## Technical Service Bulletin

67006, Life Preserver, Hammerhead, Black, CSF

<b>ISSUE DATE:</b>	June 12, 2014	<b>TSB NUMBER</b>	TSB-14-005
--------------------	---------------	-------------------	------------

Figure 3, removing the inflation cylinders

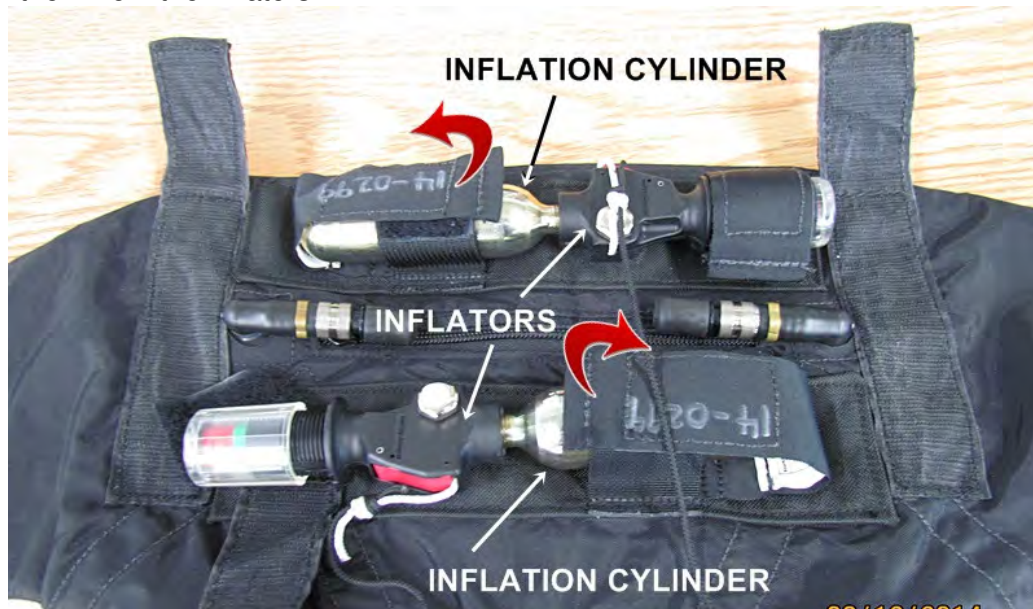
3. Open the cylinder webbing loops. Grasp the CO<sub>2</sub> cylinders and turn counter-clockwise to unscrew them from the inflators.

4. Remove the white cylinder sealing gaskets from within the two inflators using a small tool.
5. One inflator at a time, insert replacement gaskets, Tulmar p/n 3243, ensuring the gaskets are well positioned at the bottom of the inflator cavities. Diligence will be required to ensure the edge of the gasket is well tucked into the lowest groove/thread.
